Building Manager: [Robert Ian Brudvig, bbrudvig@oregonstate.edu](mailto:bbrudvig@oregonstate.edu)
 Assessment Date: 3/9/2022
 Assessment Number: **10556**
 Location: Community Hall Entire
 Reinspection date:

A joint fire safety inspection of the facility listed above was performed by the Environmental Health & Safety - Fire and Life Safety and the Corvallis Fire Department. These fire safety deficiencies could result in a fire or jeopardize the safety of those occupying the facility. Please see that these items are corrected immediately and no later than the scheduled reinspection date noted with this report. If you have any questions regarding this inspection, please email Brian Lilley (EH&S - Fire and Life Safety) at brian.lilley@oregonstate.edu.

3rd Floor Corridor

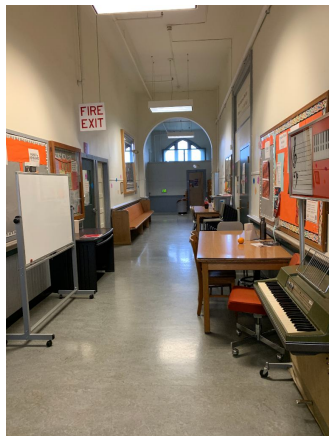
Priority code	Standard in need of attention	Reg.Reference	Location	Resp	Observations & Recommendations	Date Corrected
2	A means of egress shall be free from obstructions that would prevent its use. Combustible materials shall not be stored in exit pathways.	2019 OFC 1031.3 and 315.3.2	Hallway:corridor	DEPT	Move all items to one side keeping the other side of the hallway clear and free from obstruction.
